## Planning & Zoning Commission: April 20, 2023

### Enclave at Redwood, #MJA220003

This is a proposed Major Amendment (MJA) of the Enclave at Redwood development plan #PDP210004 that was approved in June 2022. The amendment would eliminate the vehicular street extension of Lupine Street from existing development into the Enclave development, in favor of a pedestrian, bicycle and emergency access-only connection.

Approved Plan with street connection - (possible narrowing for traffic calming added)

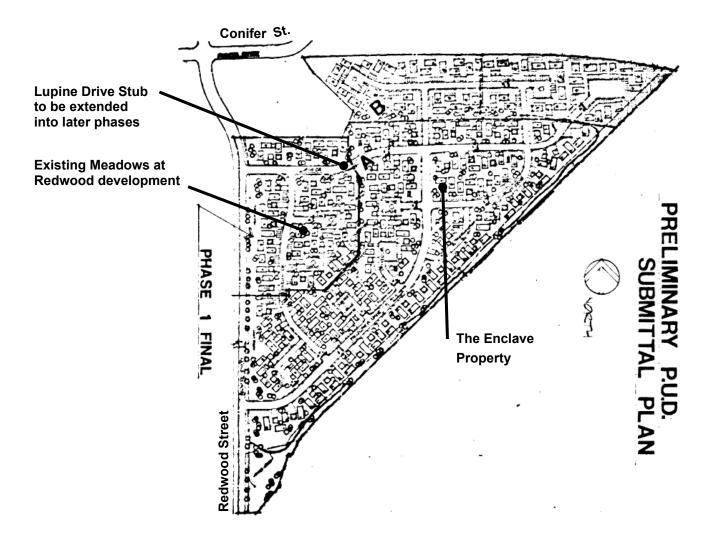
Staff finds that the purposes are better met with a local street connection at Lupine, than they would be with the alternative access, because of slightly lower efficiency and convenience for automobile traffic.
	It is a matter of degree. The proposed alternative could also fit with this purpose statement. That is, the alternative connection could be considered to be a part of the local street system, with Bergen Drive providing access for vehicles within level of service metric criteria.
	More specific evaluation is under the additional standards discussed below.

Staff does not find that the alternative compliance plan is "equal or better" considering the direction in all of this language.

If the Commission denies the Major Amendment, staff will follow up with the applicant to incorporate a narrowed "neck down" and crosswalk as a traffic calming measure to mark the transition. Staff recommends extending the narrowed portion clear to the property line, increasing the landscaping in this transitional stretch as an attractive low-speed connection.

If denied, then prior to Final Plan approval, staff will require the extension of the Lupine Street to be designed with a narrowed traffic calming "neck down" and a prominent crosswalk.
